**Natural Environment Officer response to appellant's 'Additional Material - Vastern Road Sections' dated 6th May 2022**

12.5.22

Figure 3. Plan of Area around TPO 9.

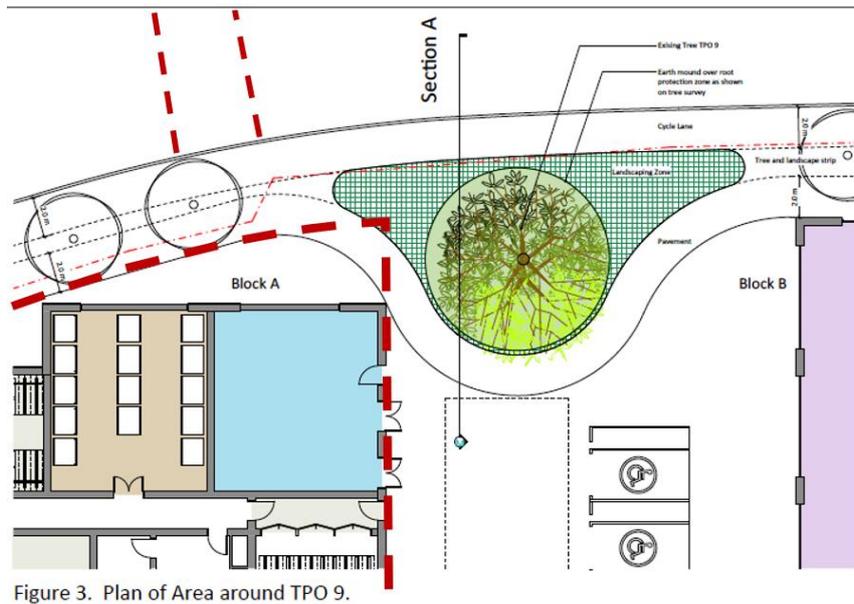
I note that Figure 3 indicates the cycle lane to be running alongside the kerb, whilst the pavement (for pedestrians) is diverted into the site and around the tree. I would suggest that if people are walking along Vastern Road, they are more likely to continue in a straight line along the roadside hence this could create conflict with cyclists - I will leave my colleague Mr Cook (Highways/Transport) to comment further on that point. It is important to note that this layout could not be achieved if Plot A was built out to its fullest extent, which is the extent we have to consider. This is shown indicatively by an annotated version of Figure 3 below (broken red line):
